## Request for Class II Permissive Change

**FCC ID:** IYG97XX

This is to request a Class II Permissive change for FCC ID: IYG97XX originally granted on 2023-10-07.

Antenna changes detail

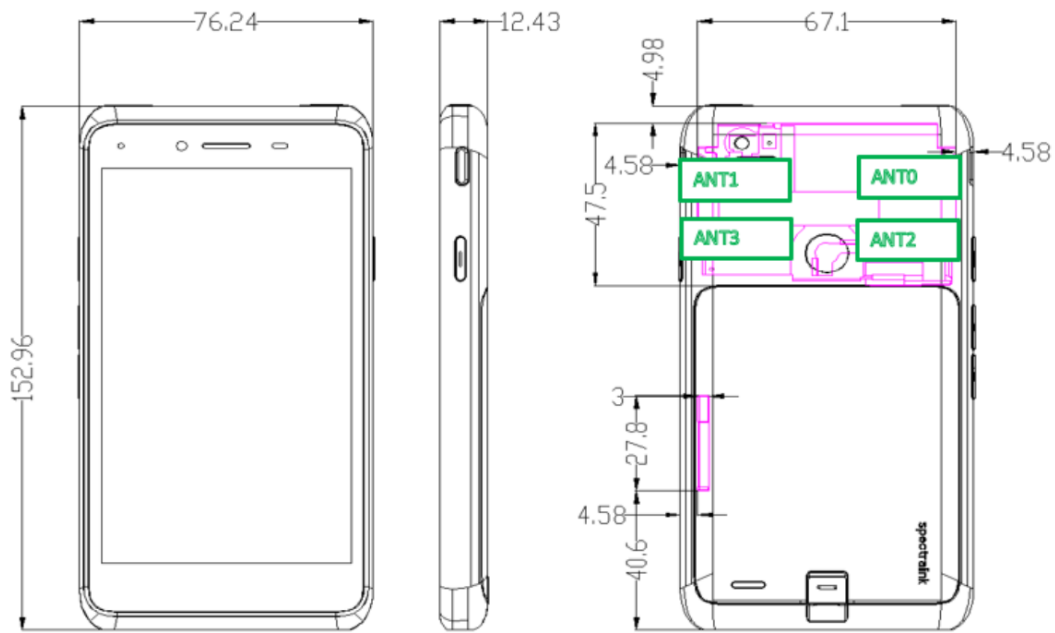
- 1. Changed the model number from Versity 9753 to Versity 9740 for the marketing purposes.
- 2. Remove Scanner and Antenna changes. Changes do not affect the PCB layout.

Versity 9753

Versity 9740
